UNITED STATES PATENT AND TRADEMARK OFFICE

APPLICATION NO.	FILING DATE	FIRST NAMED INVENTOR	ATTORNEY DOCKET NO.	CONFIRMATION NO.
09/307,633	05/07/1999	KENNETH J. NIEHOFF	L-F/104H	5115

Office Action Summary

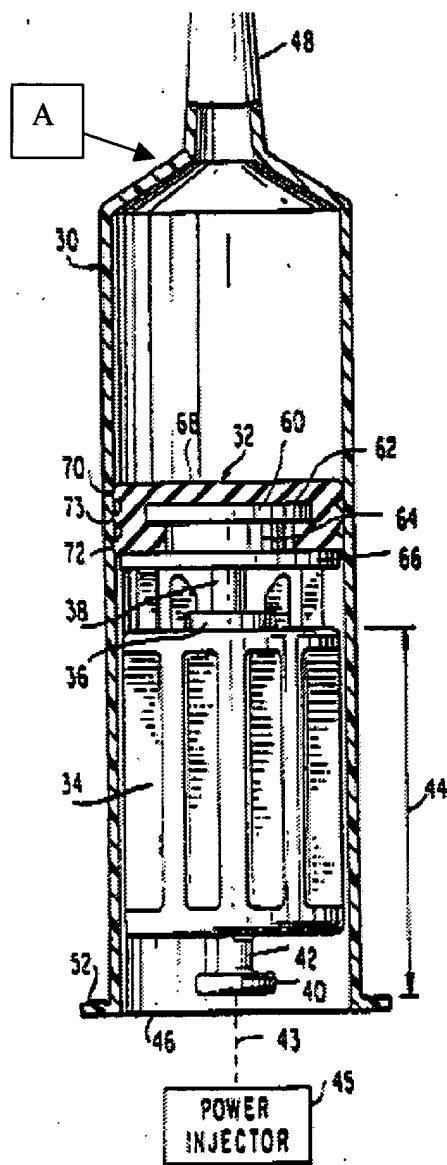
Alternatively, Stade discloses a power syringe with volume reducing adapters comprising a power injector (45), a syringe body (30) having a closed forward end (A, see labeled figure on next page) having a nozzle (48), an open rearward end (46), a plunger (32) located within the body. The power injector may be used with pre-filled syringes having standard dimensions, standard pistons, and different content volumes by way of volume reducing adapters having various fluid displacing lengths.

Stade discloses a power syringe with volume reducing adapter comprising a power injector (45), a syringe body (30) having a closed forward end (A, see labeled figure above) with a nozzle (48), an open rearward end (46), a plunger (32) located within the body. The power injector may be used with pre-filled syringes having standard dimensions, standard pistons, and
